BREECH SWABBING WARNING

AN INCIDENT
INVOLVING
ACCIDENTAL
PROPELLANT
IGNITION
DURING AN
M777A2
HOWITZER FIRE
MISSION HAS
RESULTED IN
SOME **CHANGES**
TO PARA 2-30
OF TM
9-1025-215-10
(MAY 10, W/CH
1, FEB 11).

M60A1 AVLB R&classification

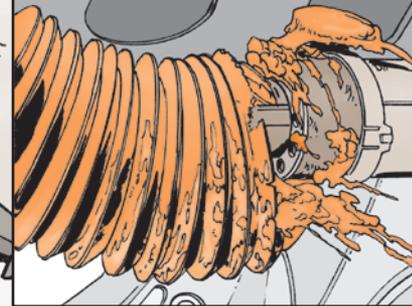
JUST BEFORE
STEP 30 ON
PAGE 2-166,
ADD THIS
WARNING...

WARNING

Crewman must swab the bore after each round fired to clear chamber of hot embers. Failure to swab the bore after each round fired may cause explosion or fire outside the breech area and cause injury or death to personnel and damage equipment.

Forgetting to swab bore after each round can ignite propellant and damage equipment

HERE ARE
FOUR OTHER
CHANGES
YOU NEED
TO MAKE
RIGHT AFTER
THE NEW
WARNING.

1. Change Step 30 to: Cannoneer No. 2 swabs powder chamber, spindle assembly, and gas check seat using chamber swab (30) after each round fired.
2. Change Step 31 to: Driver inspects cannon tube (31) and will announce BORE CLEAR after the last round of the mission.
3. Delete Step 32.
4. Renumber Step 33 as Step 32.

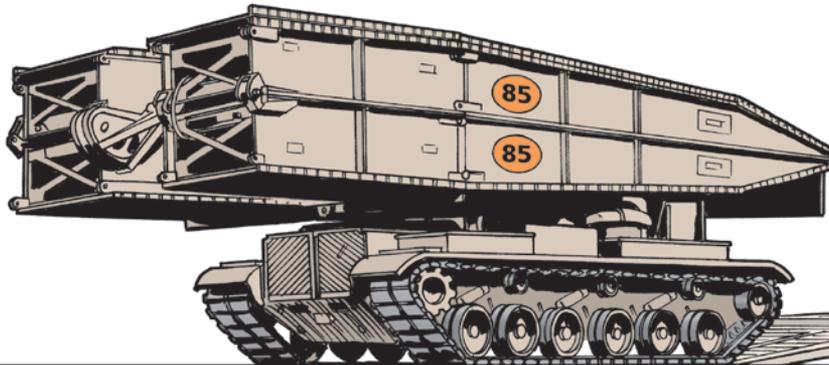
THE MLC FOR
FULLY MISSION
CAPABLE BRIDGES
HAS CHANGED FROM
70 TO 85!

The military load classification (MLC) for the armored vehicle launched bridge (AVLB) has changed.

Follow the PMCS in TM 5-2420-203-24 to completely inspect the bridge. If the bridge is fully mission capable, you can change the stencil marking in four places on the side of the bridge from 70 to 85, and the numbers on the load-disk assemblies from 70 to 85.

The numbers on the load-disk are black, 5 inches tall and on a yellow background.
